Dockets Nos. 50-250
and 50-251

The Commission has issued the enclosed Amendment No. 9 to Facility Operating License No. DPR-31 and Amendment No. 8 to Facility Operating License No. DPR-41 for Turkey Point Nuclear Generating Units 3 and 4. These amendments include Change No. 21 to the joint Technical Specifications and are in response to your requests dated September 27, 1974, February 10, 1975, and March 11, 1975, and Supplements dated February 7 and 13, March 10, April 10 and 30 and May 13, 15, and 21, 1975.

TURKEY POINT NUCLEAR GENERATING UNIT 3

ATTACHMENT TO LICENSE AMENDMENTS NOS. 9 AND 8
CHANGE NO. 21 TO THE TECHNICAL SPECIFICATIONS
FACILITY OPERATING LICENSES NOS. DPR-31 AND DPR-41
DOCKET NOS. 50-250 AND 50-251

FIGURE 3.2-1(a)

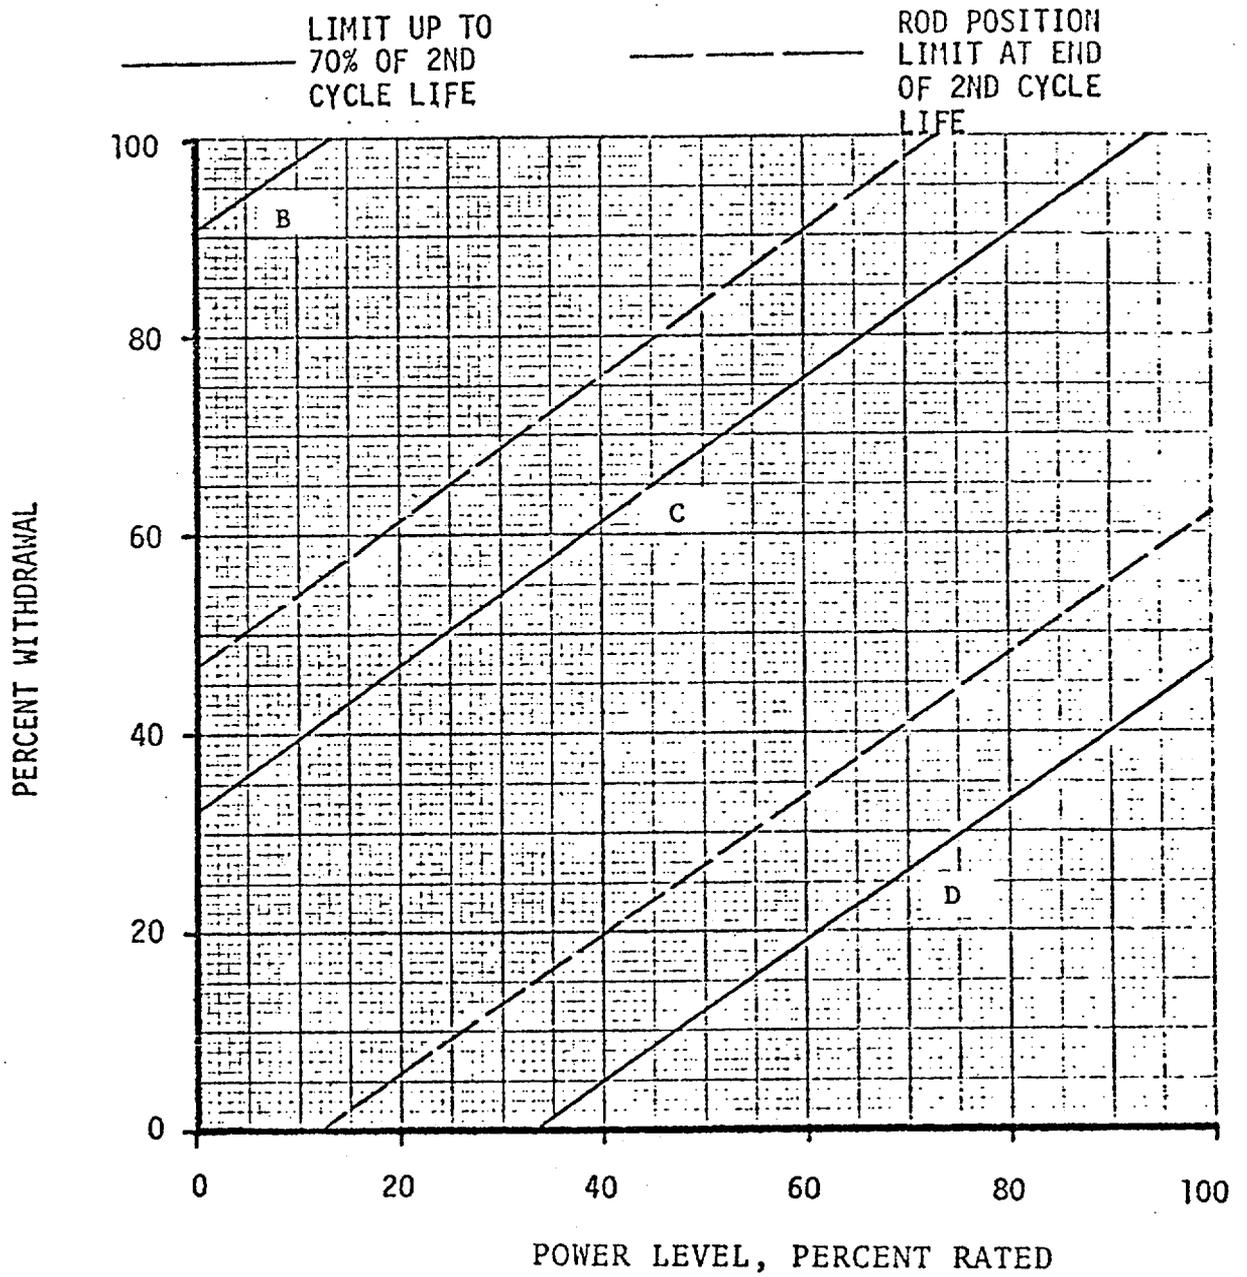
- a. Whenever the reactor is critical, except for physics tests and control rod exercises, the shutdown control rods shall be fully withdrawn.
- b. Whenever the reactor is critical, except for physics tests and control rod exercises, the control group rods shall be no further inserted than the limits shown by the solid lines on Figure 3.2-1 for three loop operation and on Figure 3.2-1(a) for two loop operation.

FPL has analyzed the control rod insertion limits for both three loop and two loop operation and has proposed Unit 4 control rod insertion limits for two loop operation which are more conservative than those presently specified. FPL has not proposed a change to the control rod insertion limits for three loop operation as their analysis shows the specified three loop insertion limits are more conservative than necessary. We have reviewed FPL's request and since we find that the use of the proposed presently specified three loop control rod insertion limits and the proposed two loop control rod insertion limits will not effect previously performed applicable safety analyses, we approve the proposed insertion limits. Use of the more conservative proposed control rod insertion limits will increase the minimum available shutdown margin, maintain an acceptable core power distribution, decrease the consequences of a control rod ejection accident and decrease the consequences of control rod misalignment.

Figure 3.2-3 HOT CHANNEL FACTOR NORMALIZED OPERATING ENVELOPE

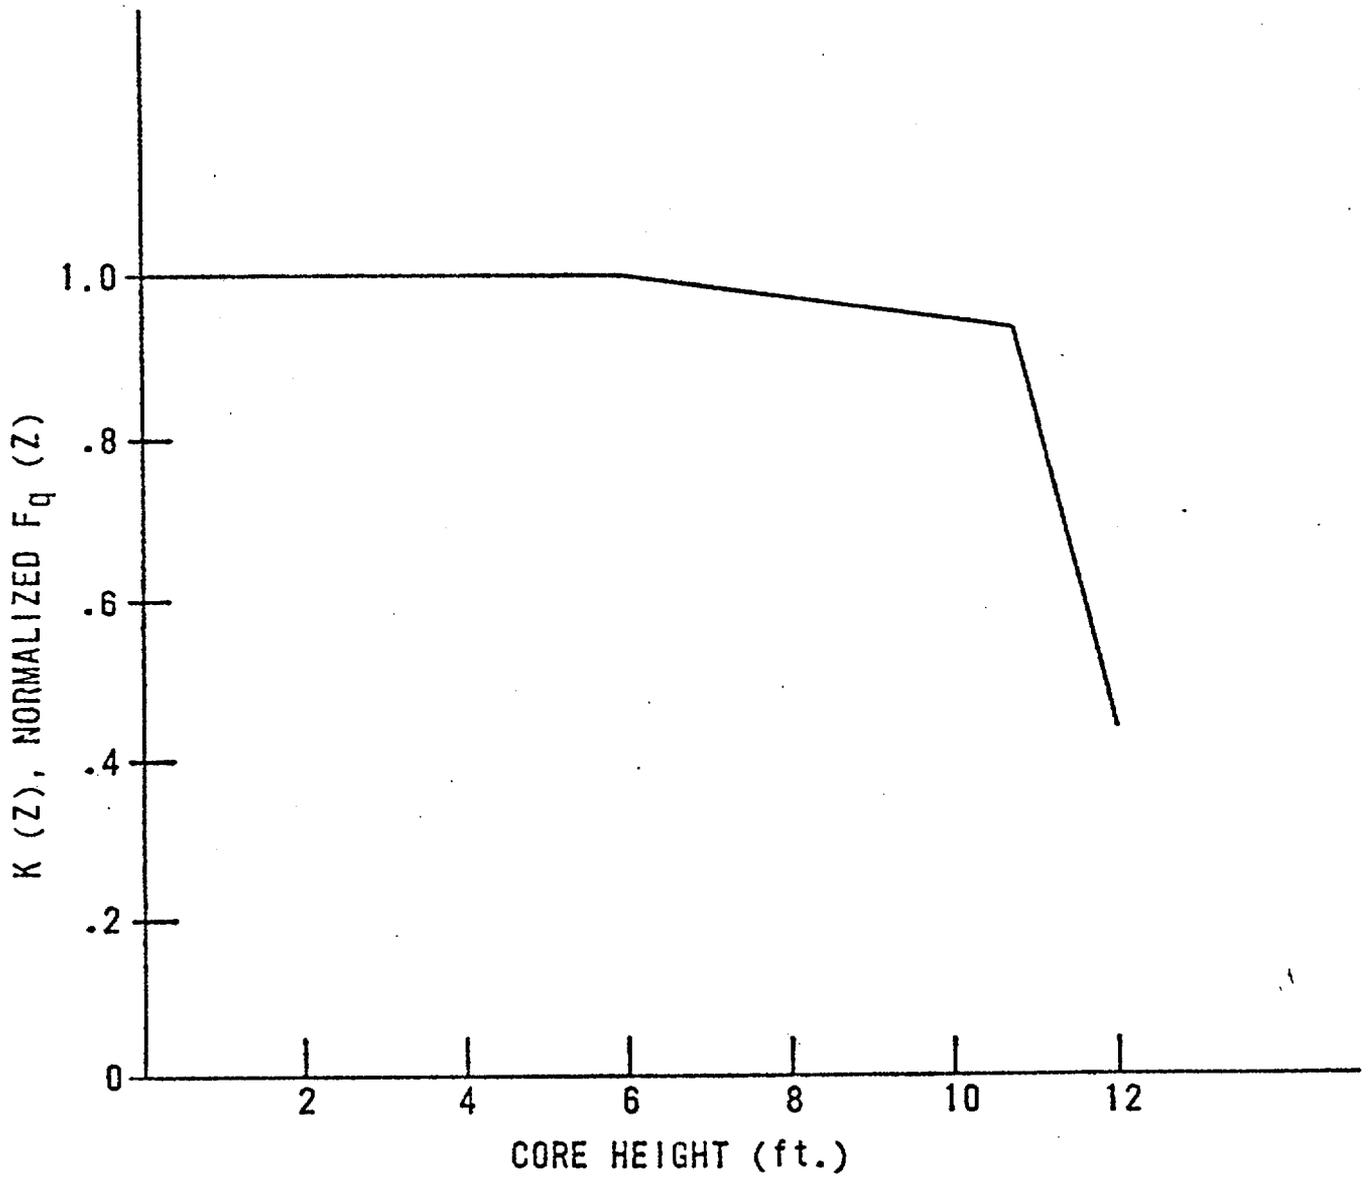
where P is the fraction of design power at which the core is operating. K(Z) is the function given in Figure 3.2-3 and Z is the core height location of F_q .

An upper bound envelope of 2.32 times the normalized peaking factor axial dependence of Figure 3.2-3 has been determined (from extensive analyses at design power considering all operating maneuvers) to be consistent with the technical specifications on power distribution control as given in Section 3.2. The results of the loss of coolant accident analyses based on this upper bound envelope indicate a peak clad temperature of 2150°F at design power, corresponding to a 50°F margin to the 2200°F FAC limit.
